DEPARTMENT OF PUBLIC WORKS

Memorandum

SUBJECT: Durham Public Works Comments related to Road Construction Regulation
Waiver Requests

Public Works Director, Rich Reine and Town Engineer April Talon P.E. have been in contact with project representative and design engineer Michael Sievert P.E. from Horizons Engineering to review the waiver requests related to the Gerrish Drive/Ambler Way Subdivision located at 91 Bagdad Road, Tax Map 10, Lot 8-6.

EMERGENCY VEHICLE TURNING PATH
Prepared for
MICHAEL HANRAHAN
TAX MAP 10, LOT 8-6
93 BAGDAD ROAD, DURHAM, NH 03824

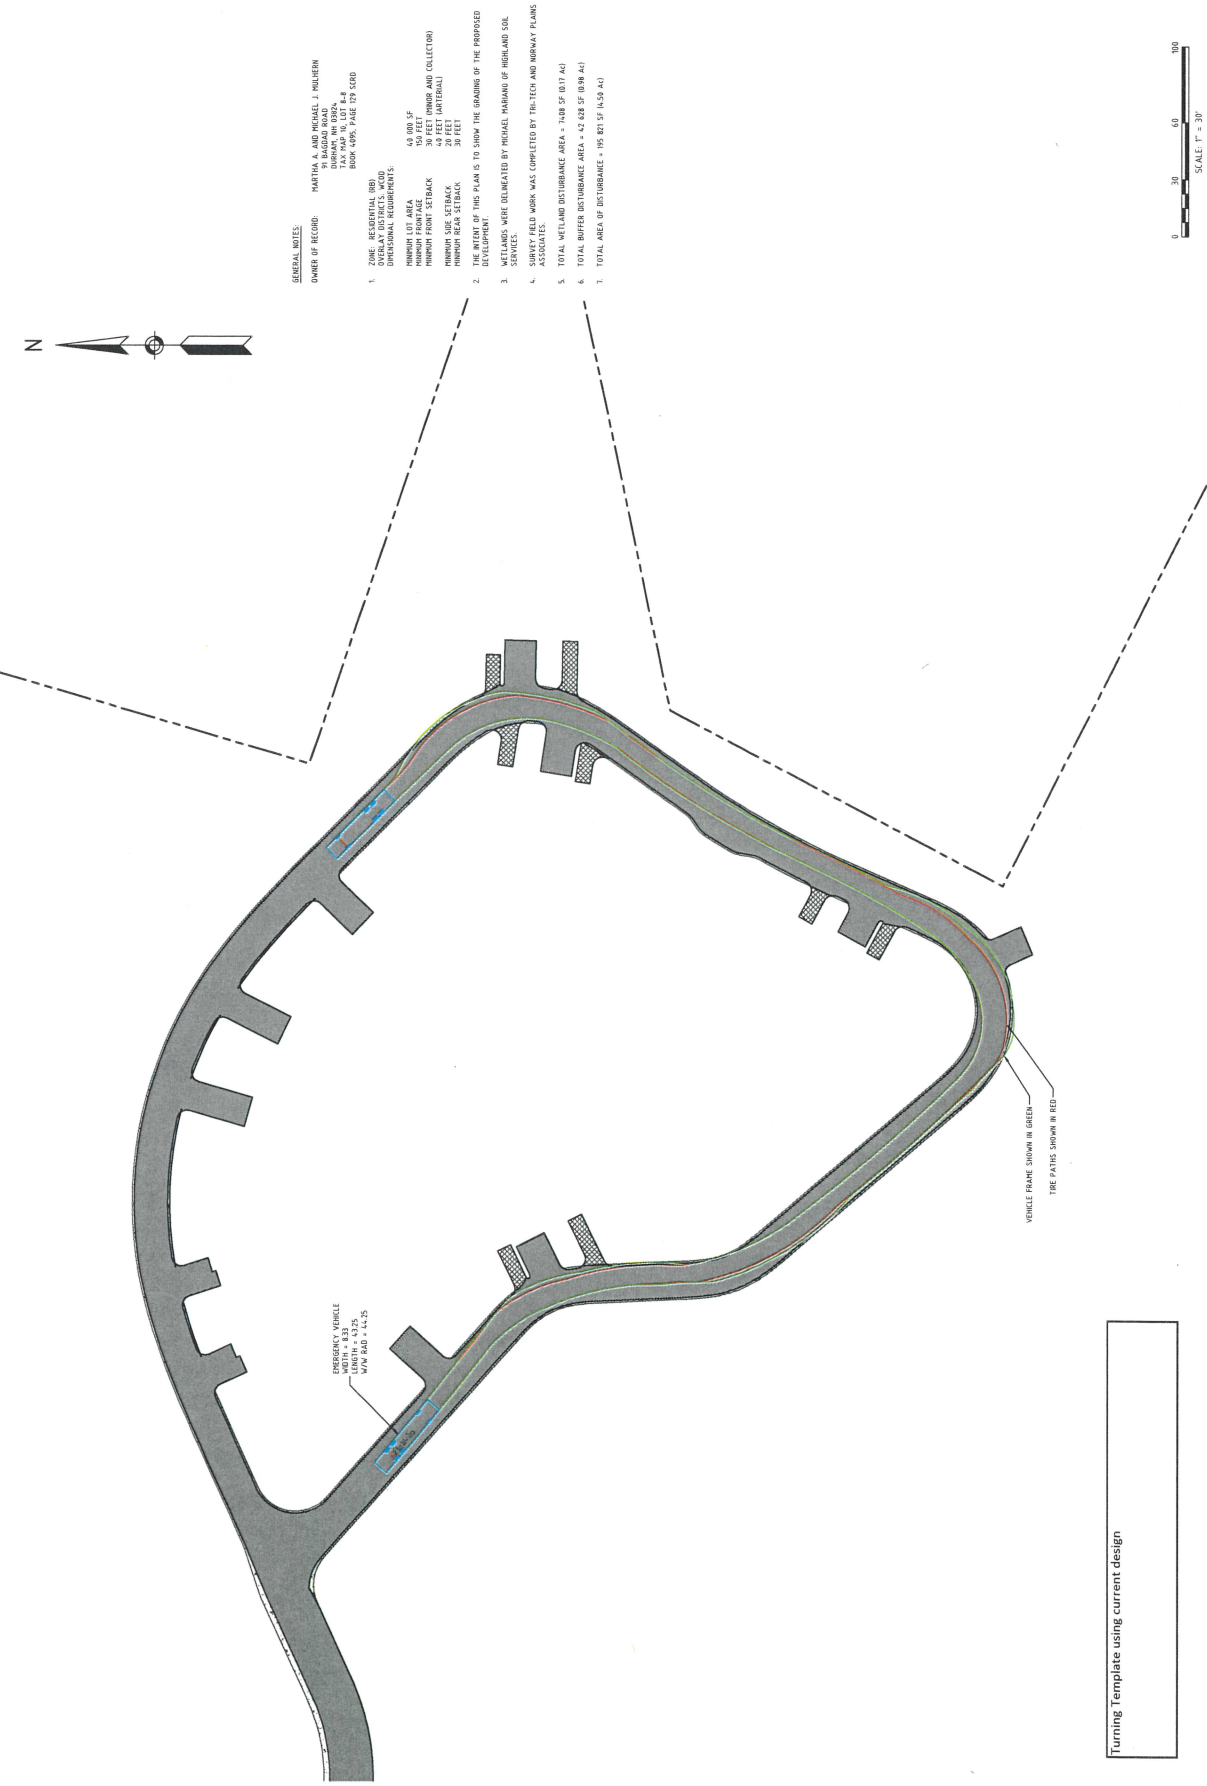
In summary, the road design guidelines per AASHTO for low volume-low speed rural and urban roads are reduced. The current design does meet this, however as you can see the vehicle tracking is tight, especially on the very tight curve. Give those findings and other factors throughout the permitting process, we have revised the design in an effort to help reduce construction costs and provide better vehicle movement. We believe that the existing design met the requirements, including the minimum requirements of the fire department, however this new revised design is more compliant. This design still requires the same waivers so there should not be any issues with the revised design.

PROJECT # 2021-06-04
 DRAWN BY RMD/063
 CHECKED BY JCS
 DATE 06/24/2021
 PROJECT # 2021-06-04
 SHEET # SK-2

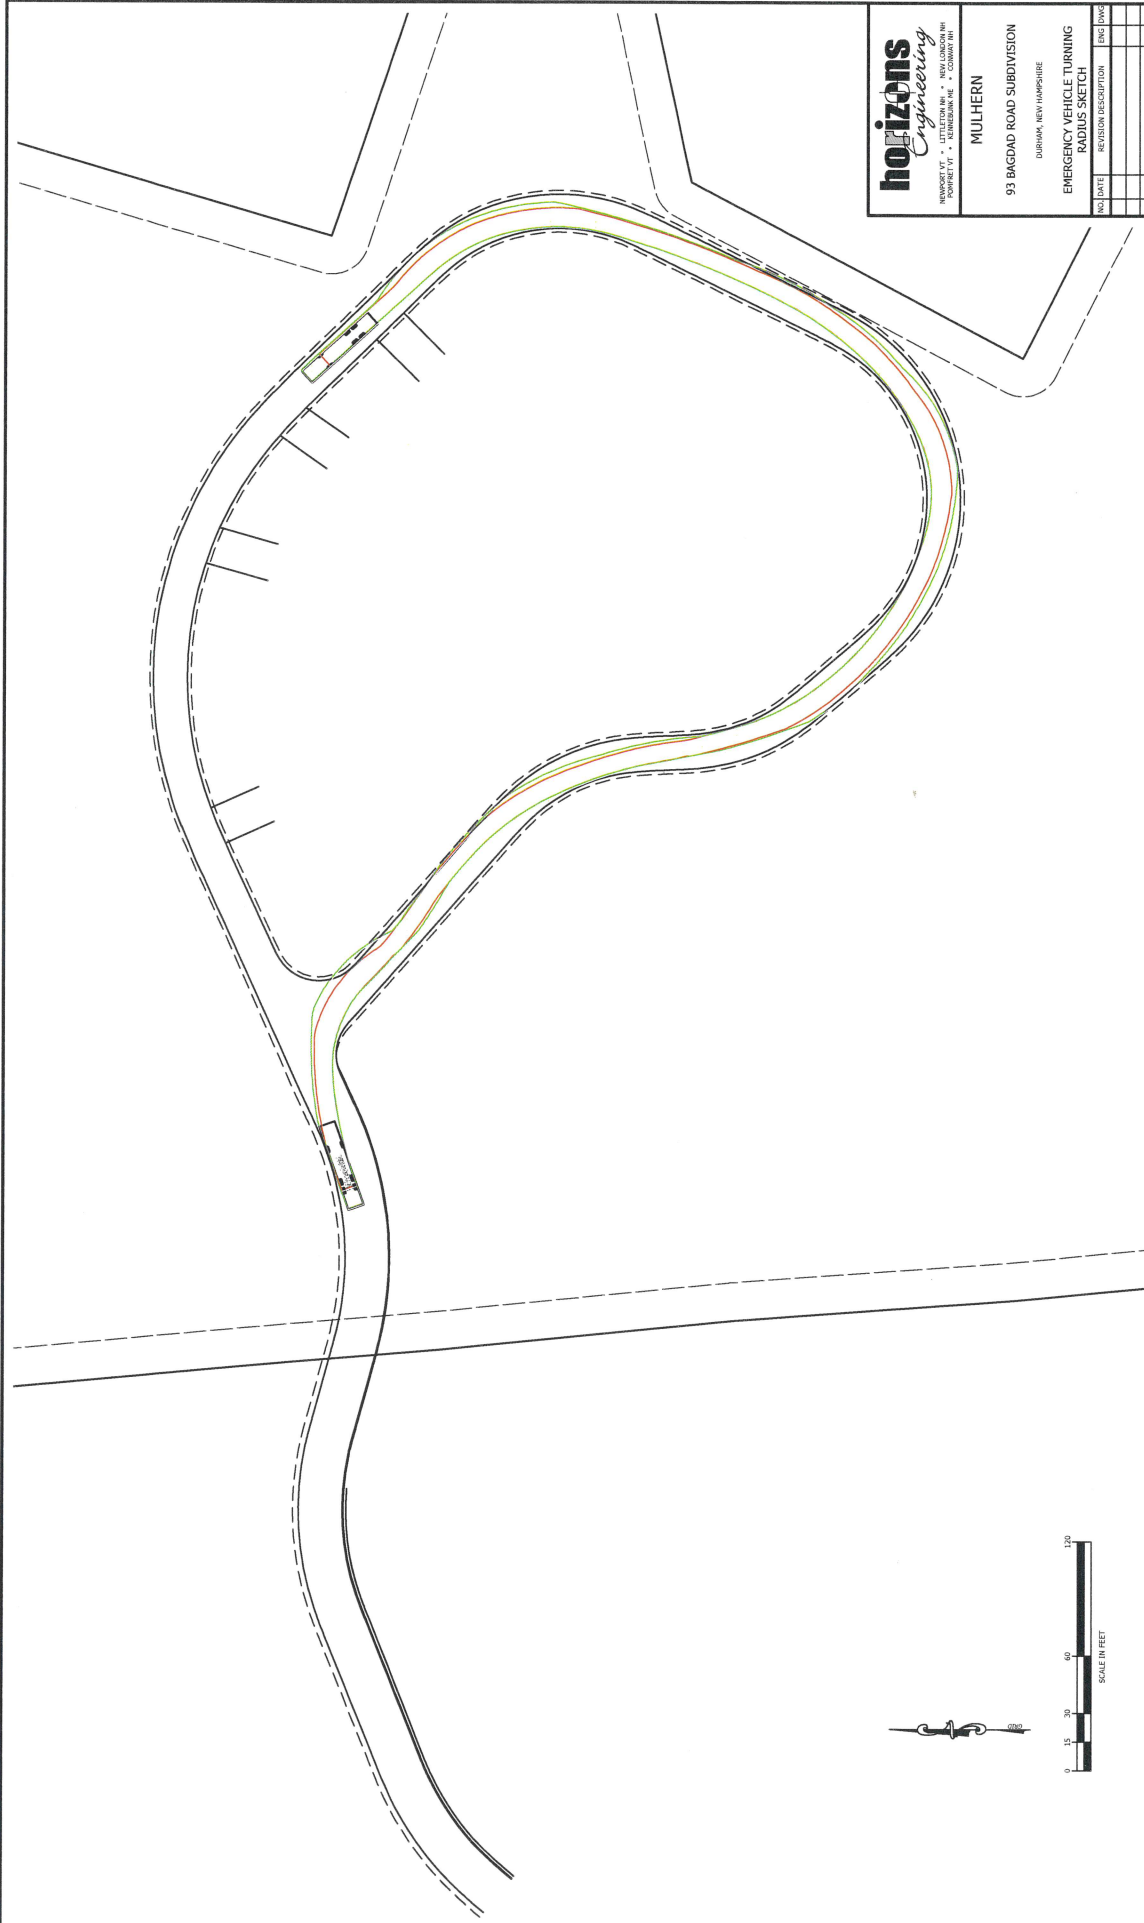
Durham Public Works response : The applicant was asked to provide a citation for the basis of design, document the design speed and submit a vehicle tracking template demonstrating that a WB40 type vehicle consistent with Town of Durham fire apparatus could successfully negotiate the roadway network. The applicant provided the attached letter and templates which supports the design decisions. Notwithstanding meeting the AASHTO standards as shown in the *"Guidelines for Geometric Design of Very Low-Volume Local Roads with an average daily traffic volume (ADT) of < 400 (AASHTO*

2001)", the Project Engineer Mike Sievert acknowledges the turning/tracking template is tight and for this and other reasons has revised the roadway design to improve vehicle circulation and safety, inclusive of modifying the curve radius located between stations 12+75 and 14+00. A revised turning/tracking template titled "NM10063 Turn Radius Updated Site Layout" has also been submitted indicating an improved geometric design. In addition, the applicant proposes to include the installation of protective guardrail beginning at station 13+50 to station 15+00, as recommended.

Durham Public Works takes no exceptions with this approach relative to minimum tangent length and minimum center line curve radius.
